Z-36
(2017)

**THE RETREAT AT
KENNESAW**
COBB COUNTY, GEORGIA
TAIN ROAD

17088
REZONE PLAN

ZONING COMMENTS:

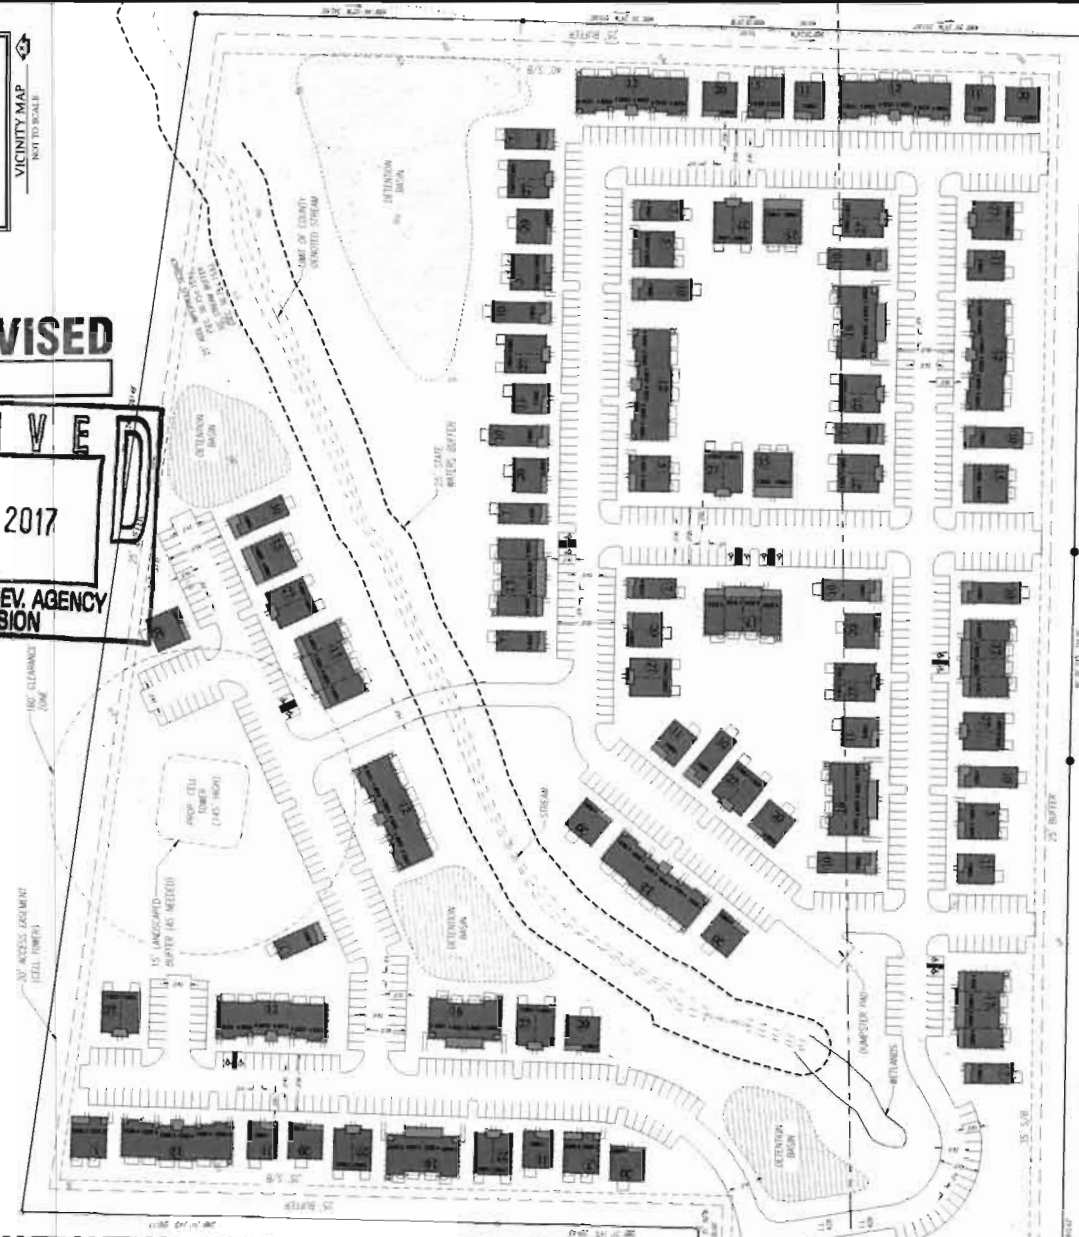
The proposed plan will also require a contemporaneous variance to waive the parking space dimension to 18 feet, instead of 19 feet deep.

ACCESS: Fire apparatus access roads shall extend to within 150 feet of all portions of the facility or any portion of the exterior wall of the first floor (State Modifications IFC 503.1 2006 Edition).

Dead-end access roads in excess of 150 feet shall be provided with a turn-around (IFC 503.2.5 2006 Edition). Cul-de-sac with or without an island: minimum 60-foot radius to outside curb, measured to inside of curb and a minimum lane width = 24 feet (Cobb County Development Standard 401.09). Single-Family cul-de-sac without island: 38-foot outside radius with island reverts to commercial dimensions. Hammerhead turn-around: total of 110 feet needed (45 feet + 20 feet wide roadway + 45 feet).

Location: Identified on site plan (no disturbance proposed).

- Provide comprehensive hydrology/stormwater controls to include development of out parcels.
- Submit all proposed site improvements to Plan Review.
- Any **spring activity** uncovered must be addressed by a qualified geotechnical engineer (PE).
- Structural fill _____ must be placed under the direction of a qualified registered Georgia geotechnical engineer (PE).
- Existing facility.
- Project must comply with the Water Quality requirements of the CWA-NPDES-NPS Permit and County Water Quality Ordinance.
- Water Quality/Quantity contributions of the existing lake/pond on site must be continued as baseline conditions into proposed project.
- Calculate and provide % impervious of project site.
- Revisit design; reduce pavement area to reduce runoff and pollution.

Recommend entrance on Chastain Road be restricted to right-in/right-out.

Recommend a deceleration lane for the entrance on Chastain Road.

- C. It is Staff's opinion that the applicant's rezoning proposal may result in a use which would cause an excessive or burdensome use of existing streets, transportation facilities, utilities, or schools. This opinion can be supported by the departmental comments contained in this analysis. Staff is concerned that this many units and parking spaces only has access to a right-in and right-out. This condition will cause a great number of u-turns east on Chastain Road.
